# UNITED STATES PATENT AND TRADEMARK OFFICE

APPLICATION NO.	FILING DATE	FIRST NAMED INVENTOR	ATTORNEY DOCKET NO.	CONFIRMATION NO.
10/821,735	04/08/2004	Michael E. Ring	MER 04069	1527

<b>Office Action Summary</b>	<b>Application No.</b>	<b>Applicant(s)</b>	
	10/821,735	RING, MICHAEL E.	
	<b>Examiner</b>	<b>Art Unit</b>	
	Mark T. Le	3617

### **DETAILED ACTION**

FIG. 7

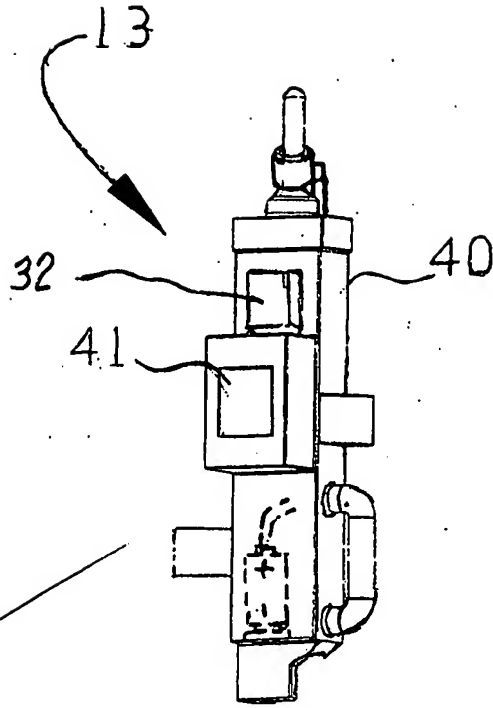
2. The replacement sheet of drawing Fig. 7 is not approved for entry because the specific arrangement of the elements of EOT device, as shown in the proposed Fig. 7, is not supported by the originally filed disclosure. To correct this problem, Applicant is suggested to provide a new drawing showing the EOT device and the associated elements in the form of a box diagram, which includes rectangular boxes representing the EOT device and the components thereof or associated therewith. Since the proposed drawing correction filed on September 14, 2007 has not been approved for entry, the previous objections to the drawings are again repeated below.

not  
approved  
for  
entry  
10/16/07  
*[Signature]*
